OPTIONAL SERVICE BULLETIN

NO. OSB 40-066

Large Rudder. ATA-Code: 55-40

WORK INSTRUCTION WI-OSB 40-066 WI-OSB D4-072 "Replacement of Rudder"

Sketch 1: Cut out for rudder mass balance

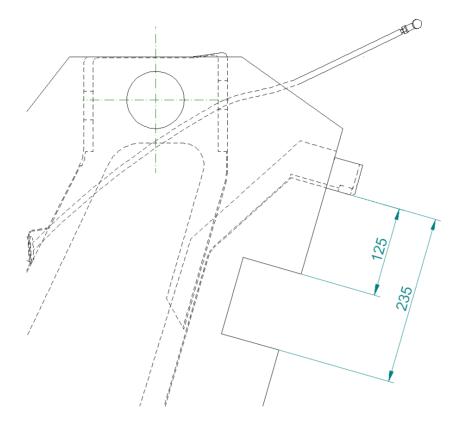
2.	Remove old rudder i.a.w. AMM Doc. No. 6.02.01 Section 55-40.
3.	Resize the rudder mass balance cut out on the vertical stabilizer (refer to Sketch 1).

4.	Install new rudder i.a.w. AMM Doc. No. 6.02.01 Section 55-40.
5.	Check for proper gap (3 mm / 0.12 in minimum) between rudder and stabilizer frame at full rudder deflection LH and RH and during travel. Check for clearance between elevator push rod and rudder mass balance in nose up and nose down position (minimum 2 mm / 0.08 in).
